Fitzhugh Road Safety Study Public Involvement Summary

Project Overview

Open House Summary

RM 12 at Fitzhugh Road Intersection

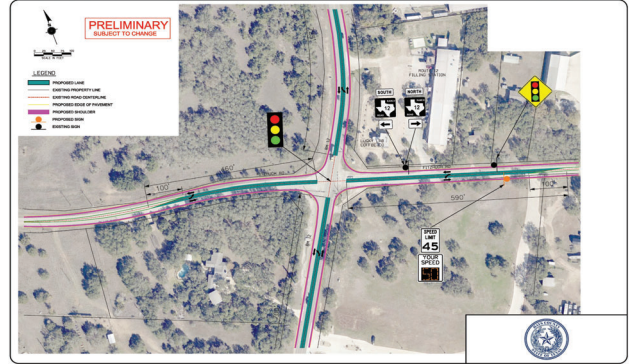
RM 12 at Fitzhugh Redesign

- Most commenters expressed support for the design.

Trautwein Road at Fitzhugh Road - Scenario A

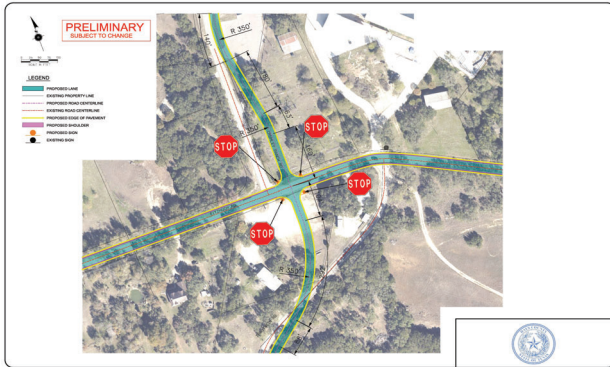
Scenario A

- Many commenters expressed support for this option, noting its sensibility and low-impact nature.
- Commenters who were opposed to this option noted drivers currently tend to drive through stop signs in the area.

Trautwein Road at Fitzhugh Road - Scenario B

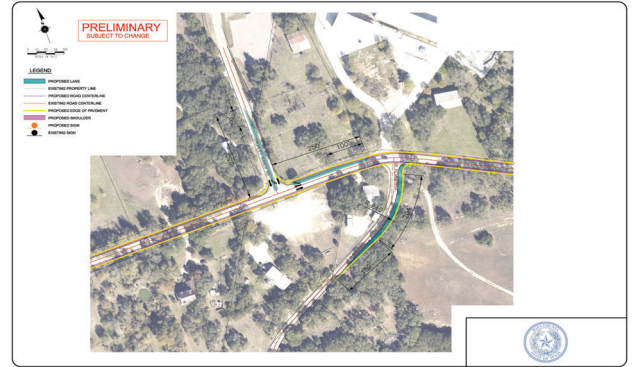
Scenario B

- Fewer commenters expressed support for this option. They noted it appeared to be the least intrusive.
- Commenters opposed to this option preferred either Scenario A or C and felt this option was intrusive.

Trautwein Road at Fitzhugh Road – Scenario C

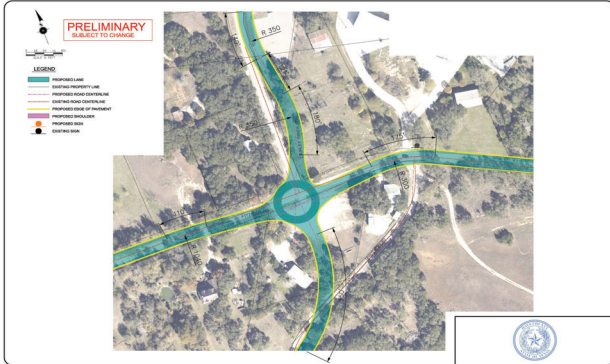
Scenario C

- Many commenters expressed support for this option due to its traffic-calming nature.
- Commenters who were opposed to this option noted that drivers in the area might not know how to properly use a roundabout and expressed concern about its impact to private property.

Barton Creek Crossing – Scenario A

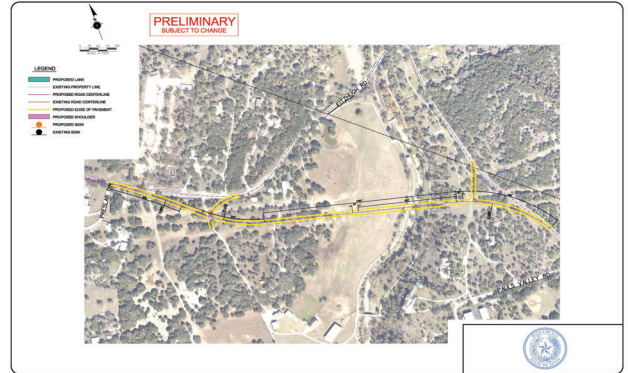
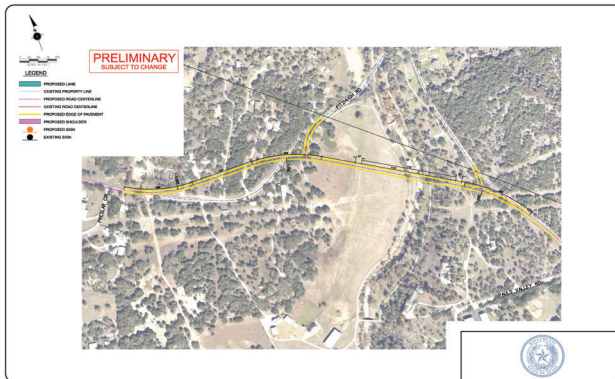
Barton Creek Crossing

- Many commenters shared that both scenarios would intrude on private property, including houses, a ranch, and a family cemetery. These commenters expressed support for a new bridge over the Barton Creek Crossing.
